UNITED STATES PATENT AND TRADEMARK OFFICE

APPLICATION NO.	FILING DATE	FIRST NAMED INVENTOR	ATTORNEY DOCKET NO.	CONFIRMATION NO.
10/758,012	01/16/2004	Tomoyuki Kojima	0051-0217P	5749

Office Action Summary	Application No. 10/758,012	Applicant(s) KOJIMA ET AL.	
	Examiner WILLIAM MCCALISTER	Art Unit 3753

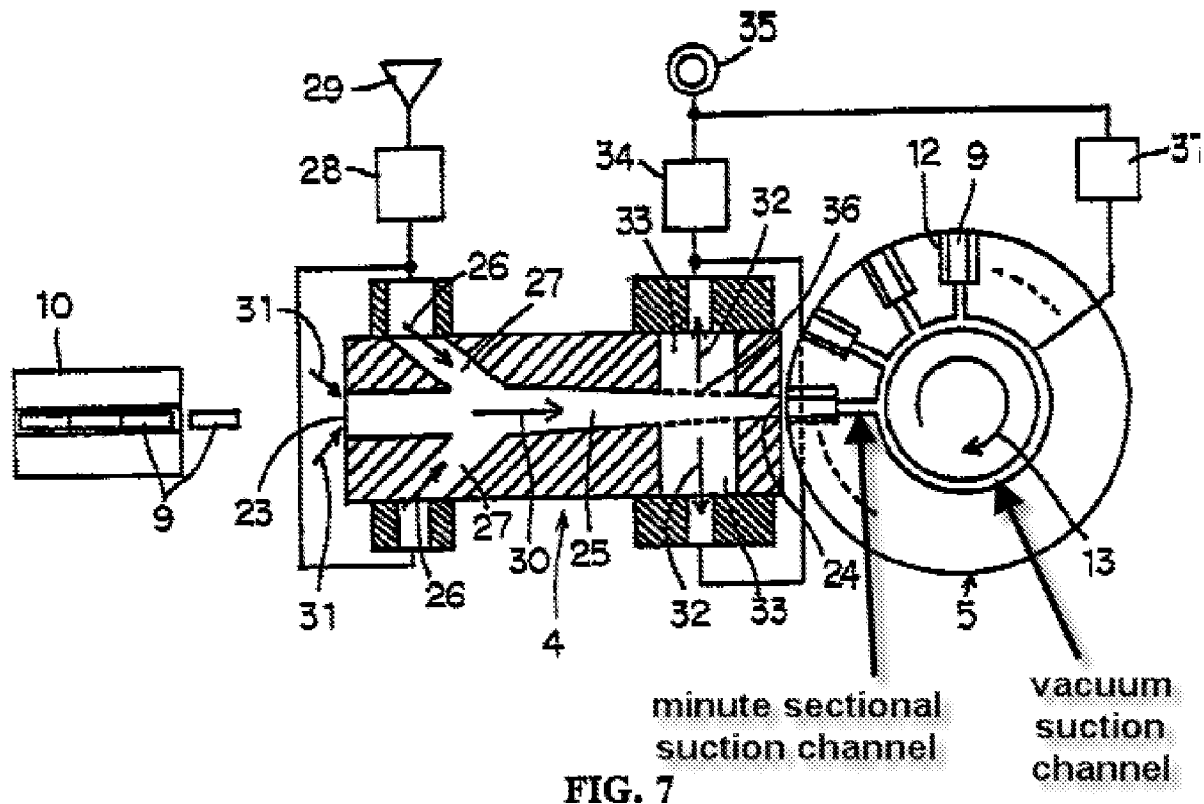
Regarding claim 3, as best understood Arishiro discloses the vacuum leak generation part to include a table base (that portion of the table 5 which defines the channels that are illustrated in FIG 7) disposed on the side of the vacuum generation mechanism of the conveyor table, with a vacuum suction channel (see annotated FIG 7, below) to connect with the work receiving opening.

Regarding claim 4, as best understood, Arishiro discloses a minute sectional suction channel (see annotated FIG 7 below) to be located between the vacuum suction channel and the work receiving opening on the side of the table base of the conveyor table.
